XTO Permian Operating LLC Respectfully requests approval to perform the bradenhead squeeze in the intermediate 2 casing after fracing operations as per Figure D in the R-111-Q document. I have attached updated design in the email. There are no changes to proposed casing points & grades and cement program top in the approved APDs

R-111-Q: Potential Potash Pivot Well Design

Operator: XTO PERMIAN OPERATING LLC. 6401 HOLIDAY HILL ROAD MIDLAND, TX 79707	OGRID: 373075
	Action Number: 419281
	Action Type: [C-103] NOI Change of Plans (C-103A)

[Figure D] 4 String – Uncemented annulus between 1st and 2nd intermediate casing strings

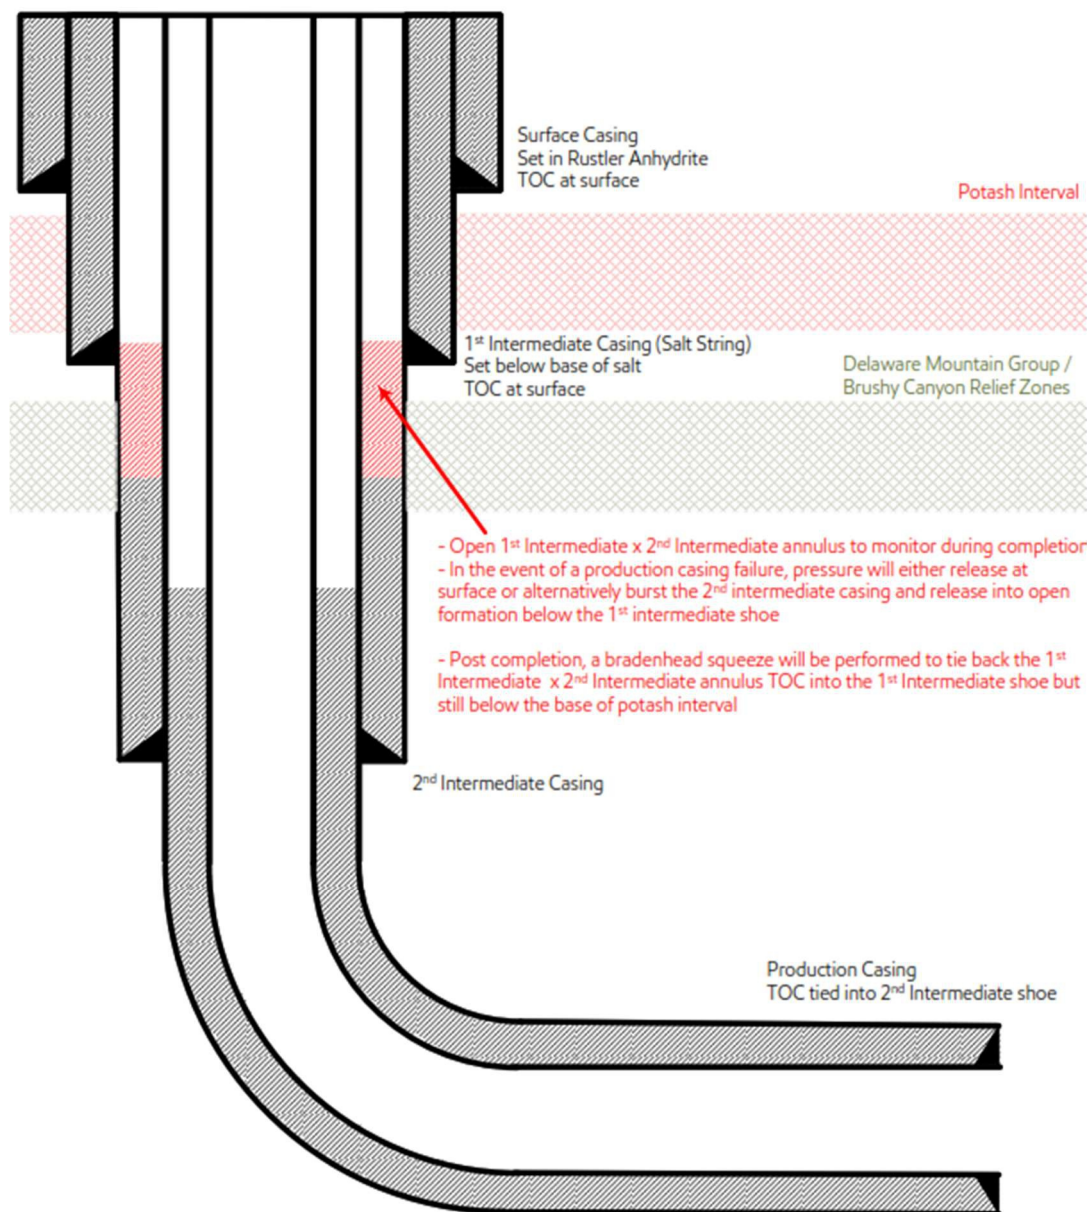
- 1) Alignment with KPLA requirements per schematic above, leaving open annulus open for pressure monitoring during frac and utilizing new casing that meets API standards.
- 2) Contingency plans in place to divert fluids away from salt interval in event of production casing failure.
- 3) Bradenhead squeeze to be completed within 180 days to tieback TOC to salt string at least 500ft but with top below Marker Bed 126.
- 4) Production cement to be tied back no less than 500ft inside previous casing shoe.

Created By	Condition	Condition Date
ward.rikala	Any previous COA's not addressed within the updated COA's still apply.	1/10/2025
ward.rikala	This well is within the R-111-Q potash area. The 1st intermediate casing string shall be cemented back to surface. Immediately following the cementing of the 2nd intermediate casing string, a CBL is required to document where the TOC is located. Immediately following the cementing of the production casing string, a CBL is required to document where the TOC is located. The bradenhead cement squeeze post frac shall provide a minimum of 500' of tie back into the 1st intermediate casing string.	1/10/2025

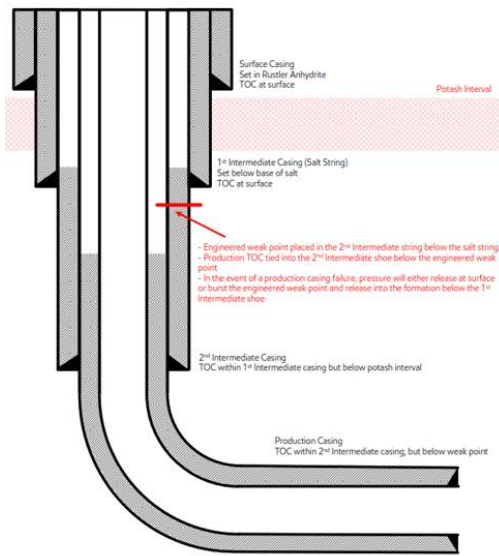
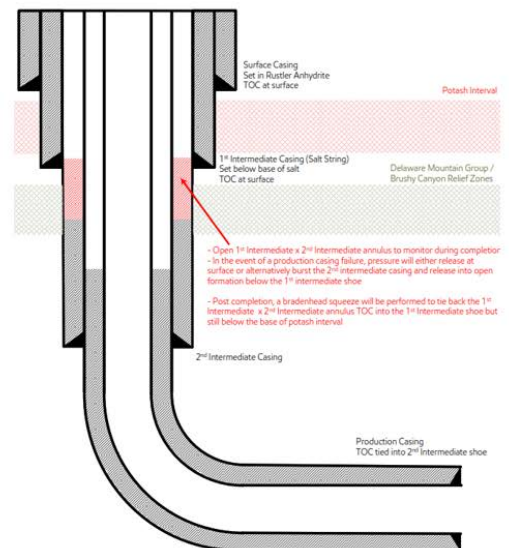
CURRENT 4-string design

[Figure F] 4 String – 2nd Intermediate casing engineering weak point

POTENTIAL pivot 4-string design

[Figure D] 4 String – Uncemented annulus between 1st and 2nd intermediate casing strings

[Figure D] 4 String – Uncemented annulus between 1st and 2nd intermediate casing strings

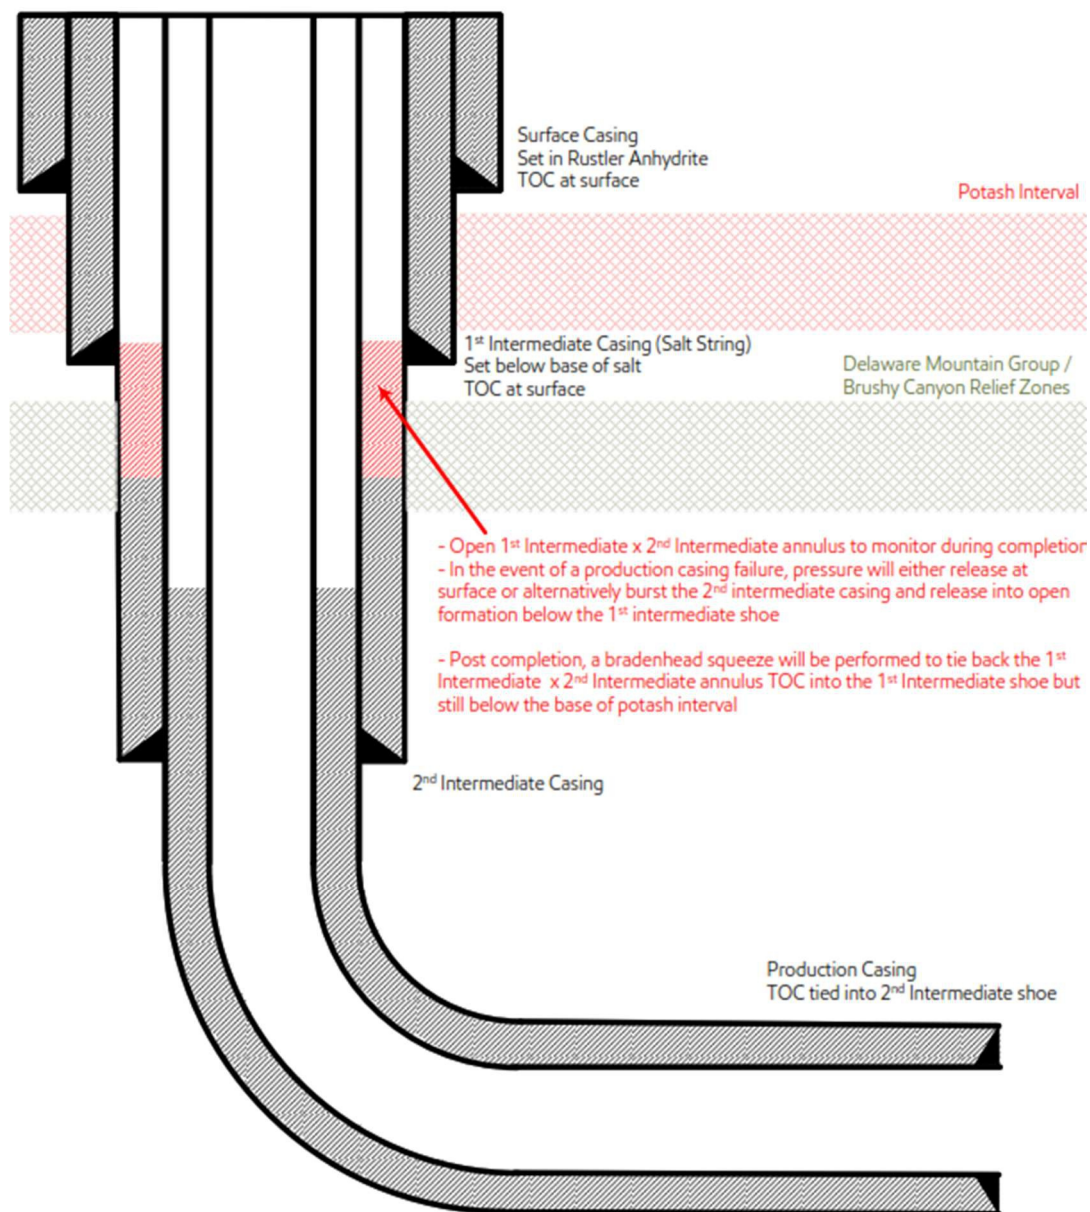
XTO Permian Operating LLC Respectfully requests approval to perform the bradenhead squeeze in the intermediate 2 casing after fracing operations as per Figure D in the R-111-Q document. I have attached updated design in the email. There are no changes to proposed casing points & grades and cement program top in the approved APDs

- 1) Alignment with KPLA requirements per schematic above, leaving open annulus open for pressure monitoring during frac and utilizing new casing that meets API standards.
- 2) Contingency plans in place to divert fluids away from salt interval in event of production casing failure.
- 3) Bradenhead squeeze to be completed within 180 days to tieback TOC to salt string at least 500ft but with top below Marker Bed 126.
- 4) Production cement to be tied back no less than 500ft inside previous casing shoe.
